INDIANA UTILITY REGULATORY COMMISSION

PETITION OF AMERICAN SUBURBAN)
UTILITIES, INC. FOR APPROVAL OF) CAUSE NO. 44676 S1
COMPLIANCE FILING AND PHASE III RATES)

TESTIMONY
OF
JAMES T. PARKS
ON
BEHALF OF
THE INDIANA OFFICE OF UTILITY CONSUMER COUNSELOR

TESTIMONY OF OUCC WITNESS JAMES T. PARKS
CAUSE NO. 44676-S1
AMERICAN SUBURBAN UTILITIES, INC.

Figure 6 – Design of new Influent Lift Station showing Valve Pit (on the left) and Wet Well (with three pumps on the right). (ASU's Engineer mislabeled the structures.)

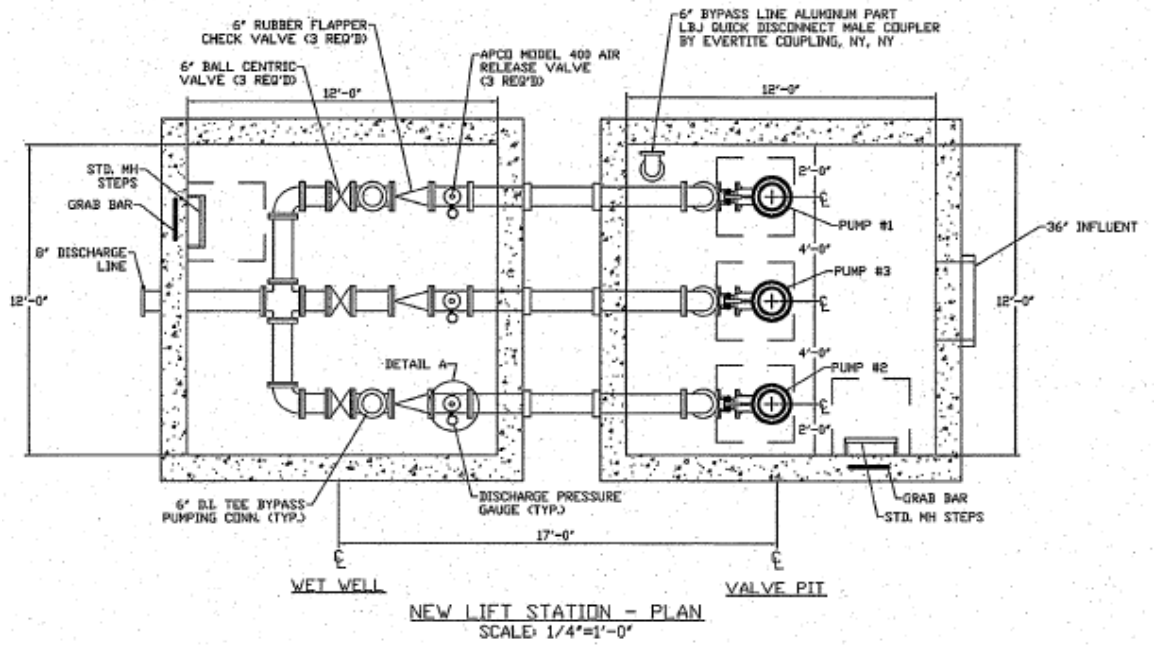
12 With the capacity for the new lift station, ASU should not have to use
13 portable trash pumps during high flows.⁹³ Photos taken during IDEM's September
14 24, 2019 inspection showed only a single macerator (instead of the required two
15 units), no pumps in the new Lift Station wet well and unfinished discharge piping.
16 See Figures 3, 4, 5, and 6. A photo taken during IDEM's March 13, 2019 inspection
17 shows a 6-inch Trash Pump on top of the existing valve pit. See Figure 7.

Figure 5– View showing the incomplete Valve Pit for the Influent Lift Station (missing air release valves, the 6” D.I. Tee bypass pumping connections, the influent flow meters, and the 6” Ball Centric valves) Photo taken during IDEM September 24, 2019 inspection.

Figure 11 – ASU’s Process Flow Schematic for Supernatant and Standby Chemical Phosphorus removal, Jan. 7, 2014. Construction Permit No. 20788, Feb. 21, 2014.

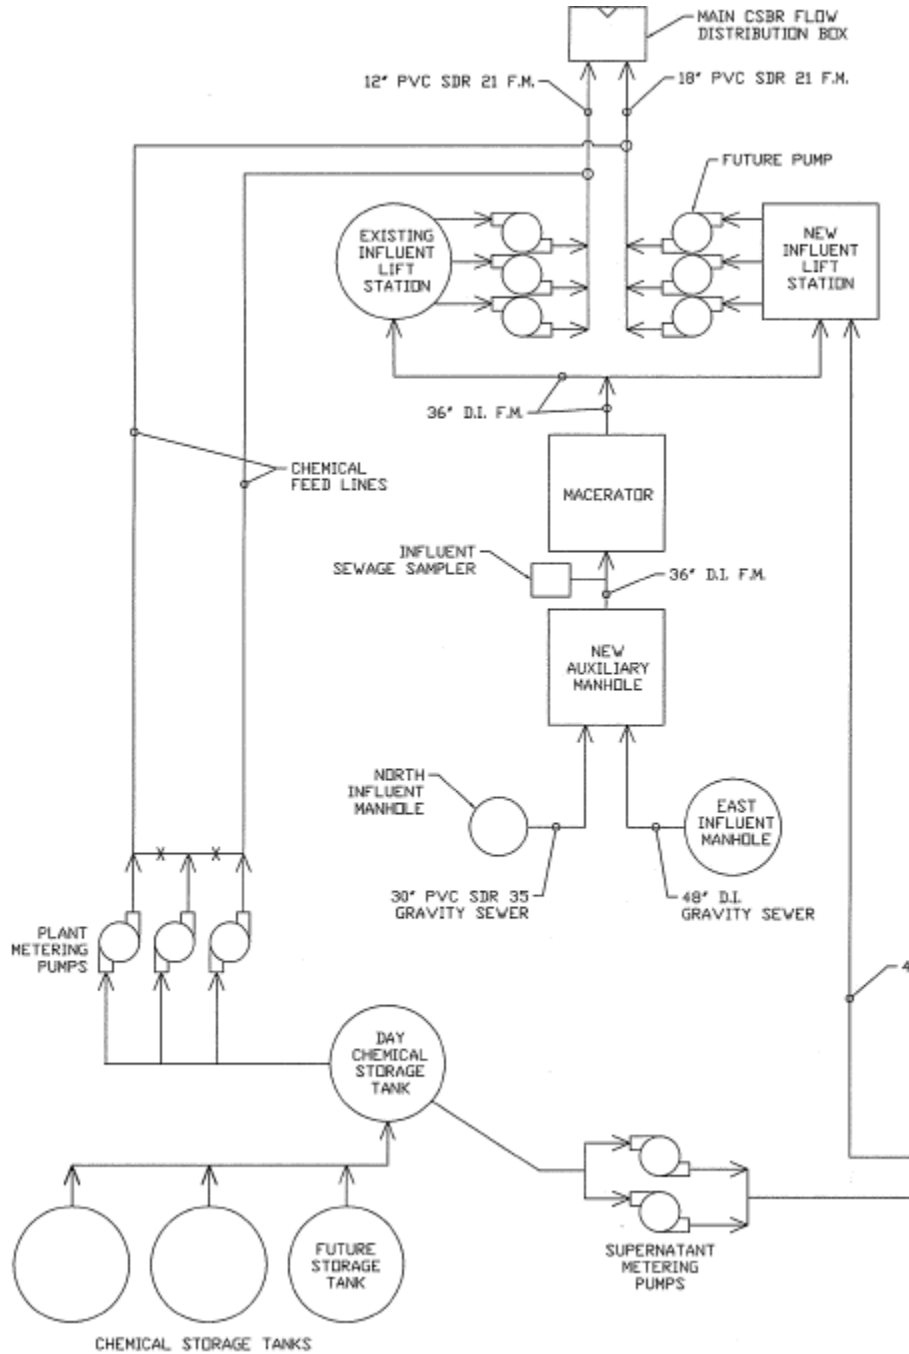
1 prevents using the same chemical, same storage tanks, same transfer pumps, same
2 metering pumps, same controls, with separate piping to remove supernatant
3 phosphorus and serve as a standby chemical system for the EBPR process. Indeed,
4 ASU's January 7, 2014 design had a single chemical system (tanks, pumps, and
5 controls) serving both needs (supernatant and standby). *See* Figure 11.

Figure 13 Phosphorus metering pump installation – March 5, 2020

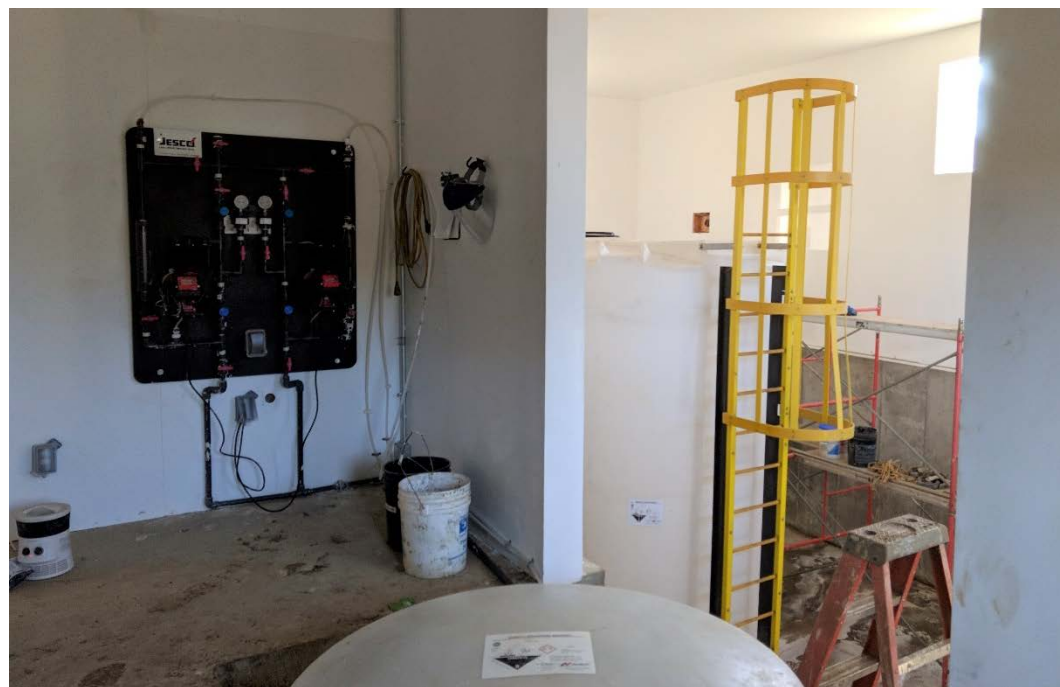
11 I observed the phosphorus work on December 4, 2019 and again on March
12 5, 2020. Each time, the work was not complete as shown in the series of
13 photographs in Figures 12 and 13. Tank work was also incomplete as well as the
14 building work previously discussed. I also suspect that ASU has not installed the
15 chemical feed piping to the original and new CSBR tanks. Instead, it appears ASU
16 is adding the chemical to the Macerator structure at Headworks. On October 8,
17 2020 I observed the phosphorus system is shown in Figure 14.
